# **Petition for Reconsideration of NHTSA’s Final Rule—The Safer Affordable Fuel-Efficient (SAFE) Vehicles Rule for Model Years 2021–2026 Passenger Cars and Light Trucks**

**Docket No. NHTSA-2018-0067**

**June 12, 2020**

Figure: BISG technology effectiveness benefits across all technology packages

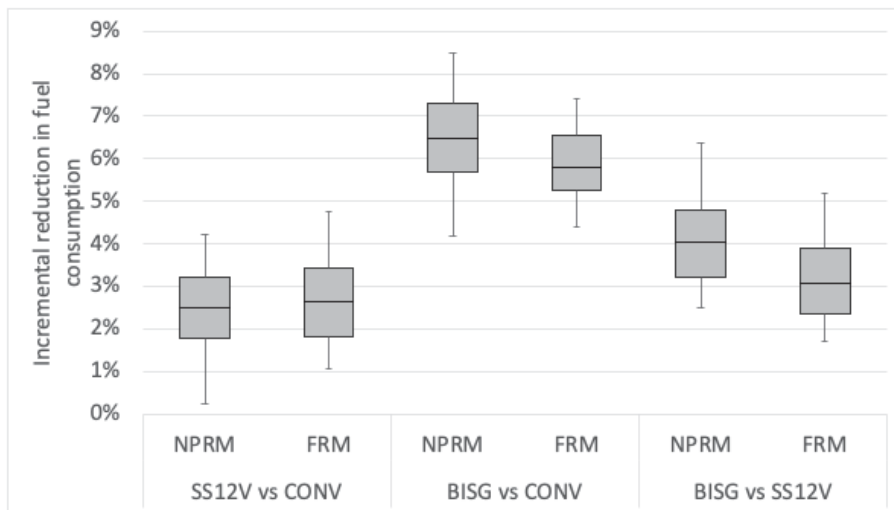
relative to SS12V, the BISG efficiency benefit decreased even more – from a midpoint of 4.0% in the Proposal to a midpoint of 3.1% in the Final Rule, though this decrease relative to SS12V is due in part to the fact that the modeled SS12V efficiency benefit improved slightly from a midpoint of 2.5% in the Proposal to a midpoint of 2.7% in the Final Rule.

But these changes are completely unacknowledged and unexplained in the Final Rule. In fact, the only discussion in the Final Rule regarding BISG relates to changes in BISG cost and battery sizes that were made in the Final Rule analysis.<sup>219</sup> Specifically, the agencies describe that they reduced BISG voltage from 110v to 48v and reduced battery size from 0.86 kWh to 0.43 kWh, and that these changes brought associated cost reductions.<sup>220</sup> However, there is no discussion whatsoever regarding how these changes could have affected the agencies’ efficiency values.
